SUBJECT: AMENDMENT NO. 21 TO FACILITY OPERATING LICENSE NO. NPF-58
 (TAC NO. 71913)

This amendment adds two containment isolation valves to Table 3.6.4-1, Containment Isolation Valves, and one valve control switch to Table 3.3.7.4-1, Division 1 Remote Shutdown System Controls.

PERRY NUCLEAR POWER PLANT, UNIT NO. 1

SAFETY EVALUATION BY THE OFFICE OF NUCLEAR REACTOR REGULATION
RELATED TO AMENDMENT NO. 21 TO FACILITY OPERATING LICENSE NO. NPF-58

Figure 1
PRESENT ARRANGEMENT
(SIMPLIFIED)

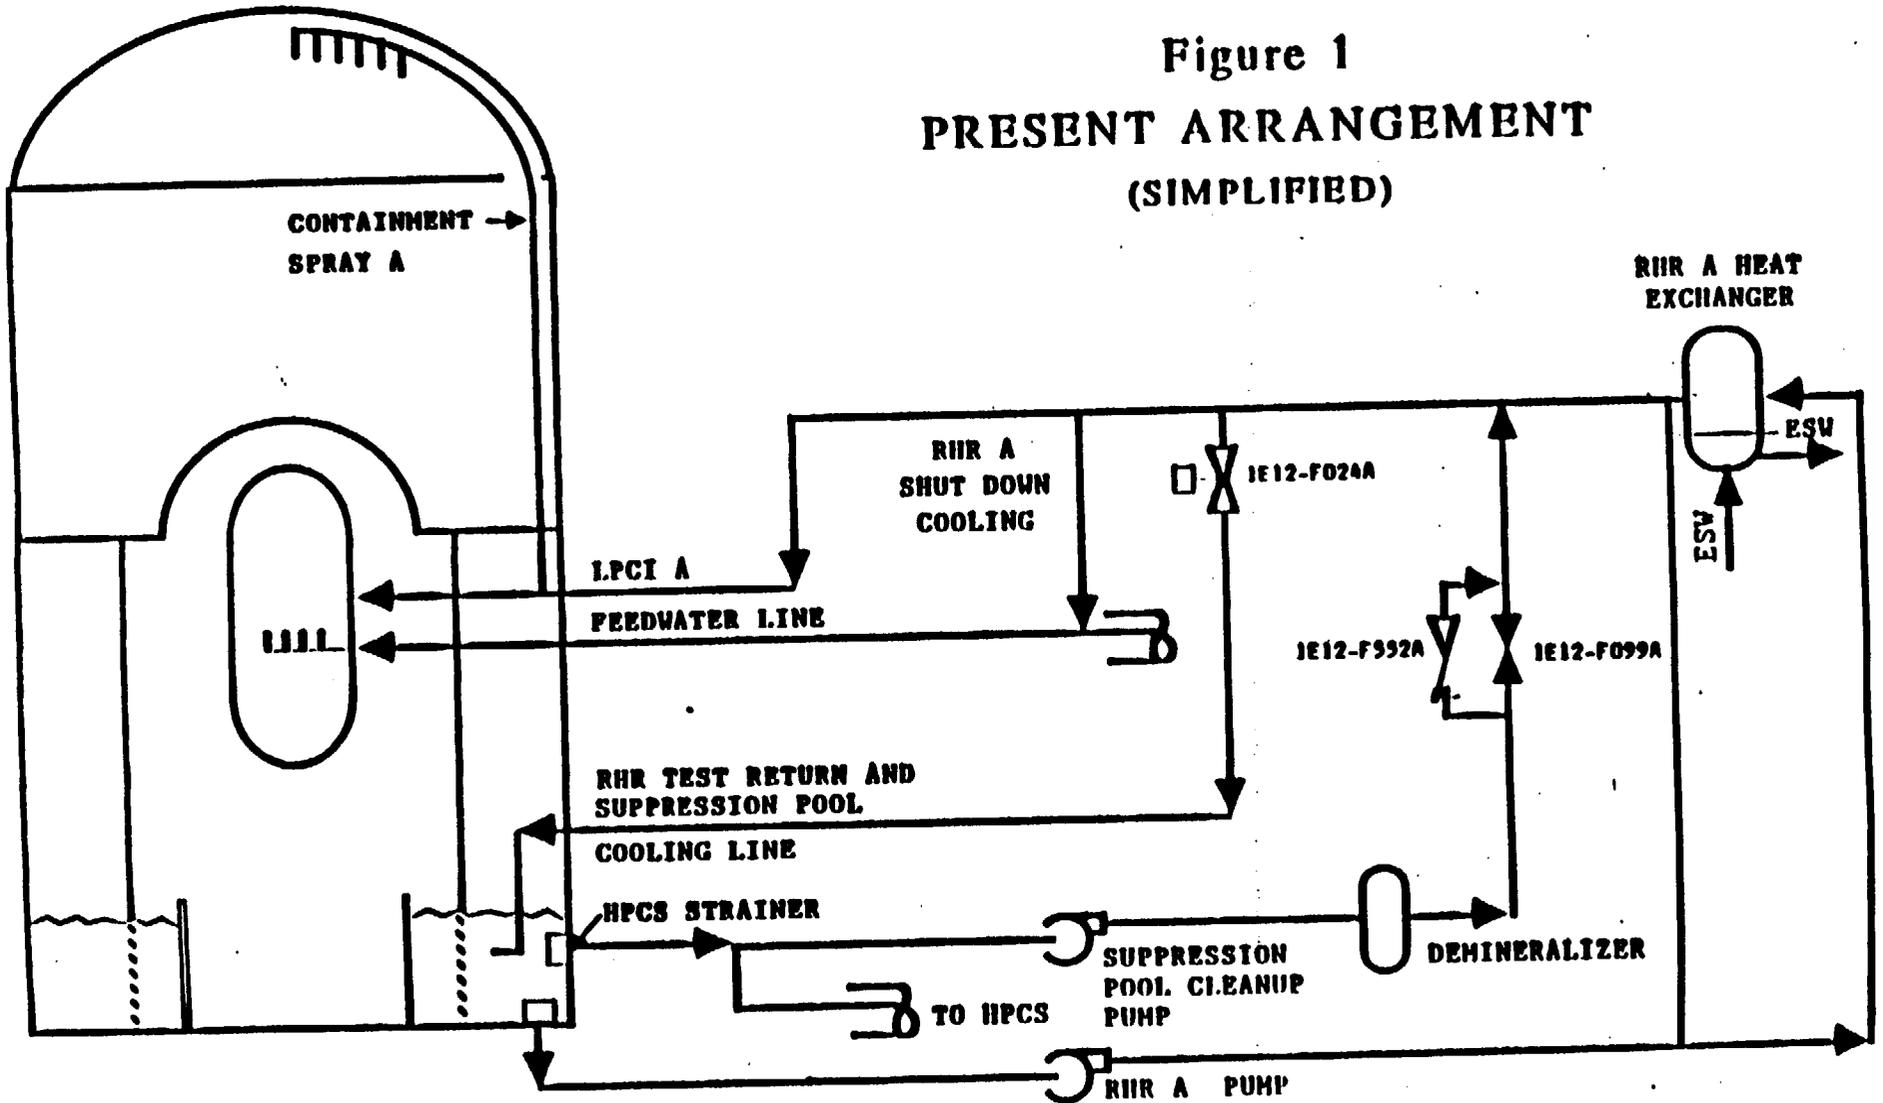
Currently, the return line of the Suppression Pool Cleanup System (G42) ties into either loop A or B of the RHR (E12) system upstream of the respective suppression pool isolation valve (E12-F024A/B). (See Figure 1). During Suppression Pool Cleanup operations, it requires the opening of isolation valve E12-F024A/B. This drops the pressure in either A or B loop of the RHR system below the system low pressure alarm setpoint, rendering that loop inoperable.

A modification is proposed for the first refueling outage to relocate the return of the Suppression Pool Cleanup System to a point on the A loop of the RHR System between the isolation valve (E12-F024A) and the suppression pool, thus allowing the E12-F024A valve to remain shut during Suppression Pool Cleanup operations (See Figure 2). Both RHR loops could then remain operable throughout Train A SPCU System operations (preferred configuration).

The proposed return line utilizes the same existing containment penetration and adds two automatic containment isolation valves (1E12-F609 and 1E12-F610) to the line. (See Figure 2). Both valves will be located in the Auxiliary Building as close as possible to the outside of the containment, receiving Valve Group 1 containment isolation signals (Reactor Pressure Vessel low level 2, and high drywell pressure). The proposed isolation signal is more conservative than the existing isolation signal on Level 1 for valve 1E12-F024A. The power supplies to the valves are independent (1E Division 1 power goes to 1E12-F609, and 1E Division 2 power goes to 1E12-F-610) so that any single failure would not prevent containment isolation.

Based on the above review and evaluation, the staff finds that the proposed additional isolation valves and piping provide single failure proof, seismic Category I quality, appropriate valve closure time, remote control shutdown capability and leak tight barrier by a water seal for at least 30 days during an accident. Therefore, the staff has determined that the proposed modification to the system design meets SRP Section 6.2.4.II. acceptance criteria in satisfying GDC 1, 2, 4, 16, 54, and 56 to 10 CFR Part 50, Appendix A and that the proposed Technical Specification change is acceptable.
